INCH-POUND
MIL-PRF-19500/608D
w/AMENDMENT 1
8 March 2010
SUPERSEDING
MIL-PRF-19500/608D
24 August 2009

PERFORMANCE SPECIFICATION SHEET

SEMICONDUCTOR DEVICE, DIODE, SILICON, SCHOTTKY, POWER RECTIFIER, COMMON CATHODE, COMMON ANODE CENTER TAP, DOUBLER, TYPES 1N6660, 1N6660CCT1, 1N6660R, 1N6660CAT1, AND 1N6660DT1, JAN, JANTX, JANTXV, AND JANS

* FIGURE 6. Avalanche energy test circuit.

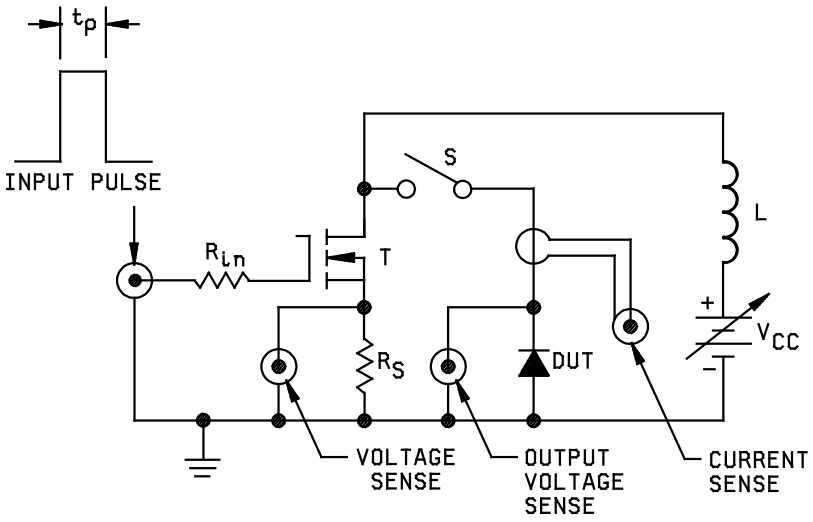
* 4.3.3 Avalanche energy test. The avalanche energy test is to be performed using the circuit as shown on figure 6 or equivalent. The Schottky rectifier under test shall be capable of absorbing the reverse energy, as follows: I_{AS} = 2 A minimum, L = 260 μH.
